1 INTRODUCTION

On April 15, 2019, Humboldt County (County) released to the general public and public agencies the draft environmental impact report (DEIR) for the Humboldt Wind Project. The DEIR contains an environmental analysis of potentially significant effects of implementing the proposed project. Together, the DEIR and this document, which includes the response to comments on the DEIR and additional technical information, constitute the final environmental impact report (FEIR) for the Humboldt Wind Project.

Figure 1-1a Comparison of Original (DEIR) and Refined (FEIR) Project Disturbance Limits

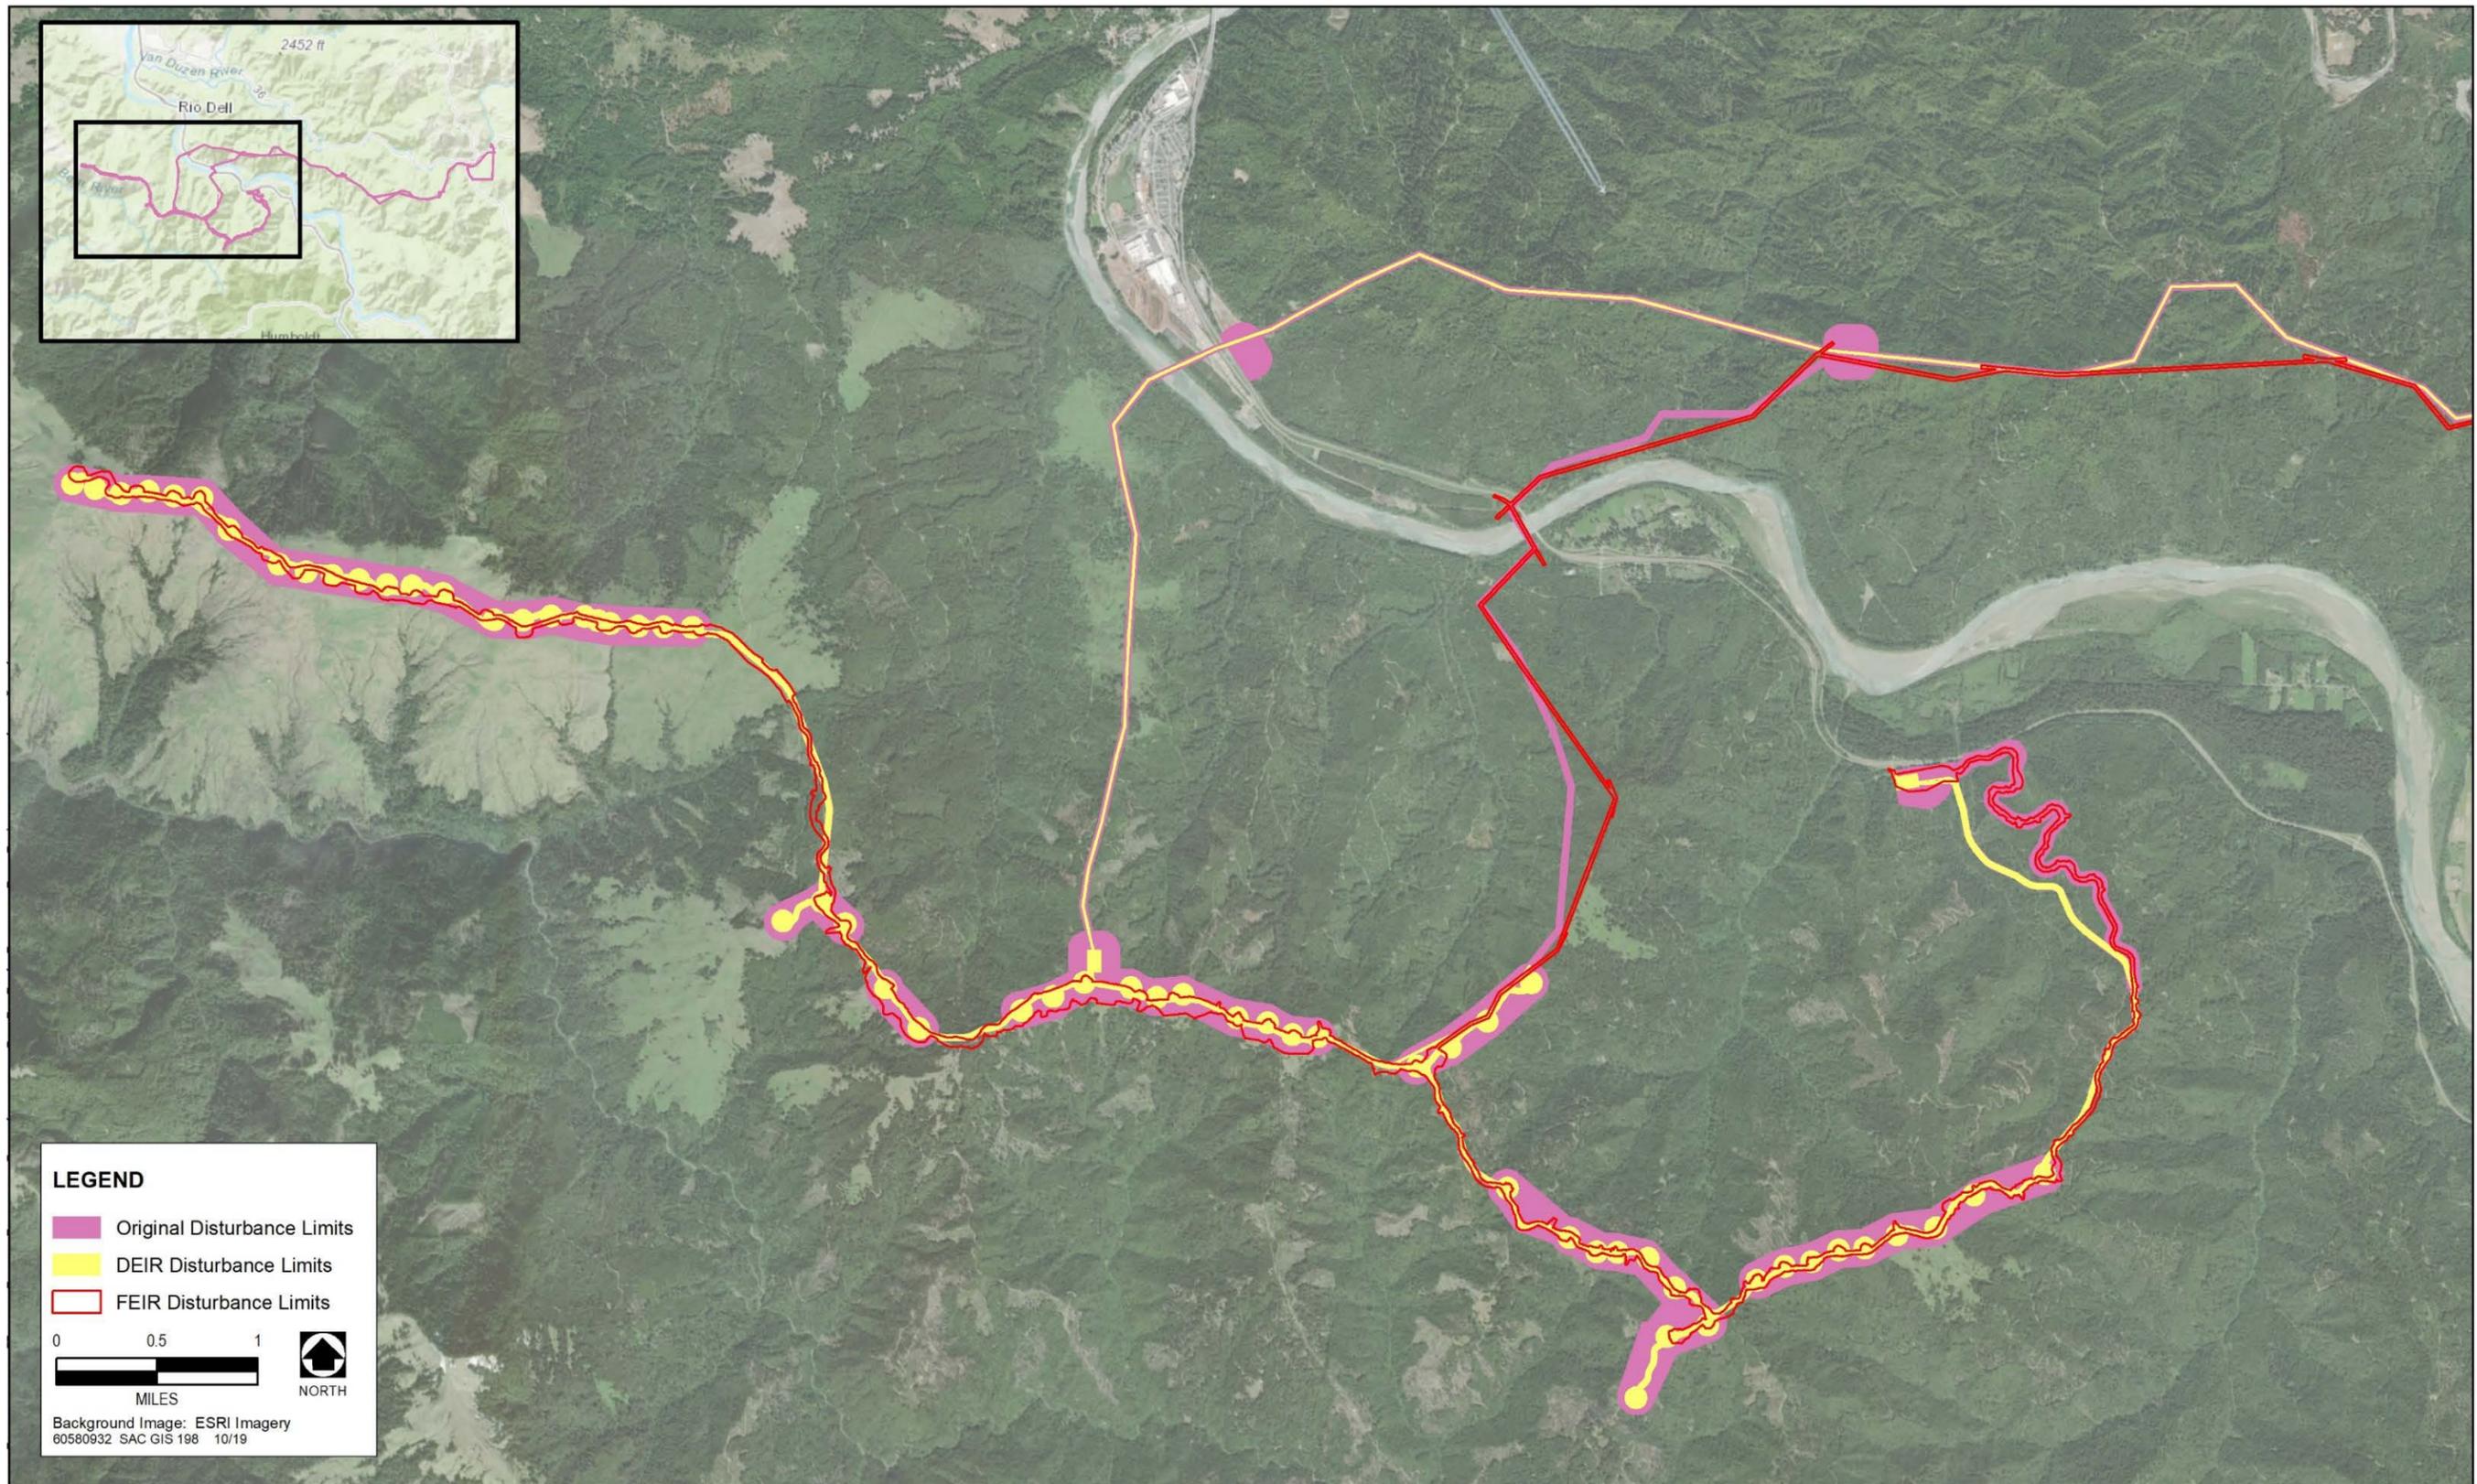
Overall Reduction in Anticipated Ground Disturbance. Since the circulation of DEIR, the applicant has refined the project footprint by narrowing the project corridor and micro-siting wind turbine generators (WTGs). This has resulted in a reduction of the anticipated ground disturbance footprint from approximately 900 acres of permanent and temporary impacts analyzed in the DEIR to approximately 655 acres discussed in this FEIR. Figure 1.1 shows a comparison of the DEIR and FEIR project footprints.

Reduction in the number of WTGs from 60 to 47. Since circulation of the DEIR, the applicant has reduced the number of proposed WTGs from 60 to 47, spread across Monument Ridge and Bear River Ridge. The location of the proposed WTGs is shown in Figure 1-1. Through this micro-siting of each individual WTG, the project applicant was able to further avoid and/or minimize impacts. Specific impacts addressed through micro-siting or removal of proposed WTGs include: avoidance of known cultural resource sites on Bear River Ridge; avoidance and minimization of impacts on biological resources, in particular marbled murrelets and northern spotted owls by removing WTGs from areas of known high activity of these species; and elimination of significant noise impacts on sensitive receptors by removing a WTG from the vicinity of a residence. The number of WTGs on Bear River Ridge was reduced from 23 to 20 and the number of WTGs on Monument Ridge was reduced from 37 to 27 turbines.

Reduced Substation Footprint. The applicant now proposes a reduced footprint for the project substation from approximately 5 acres to 2.5 acres to reduce overall site disturbance. The reduced substation footprint is shown in Figure 1-1 below.
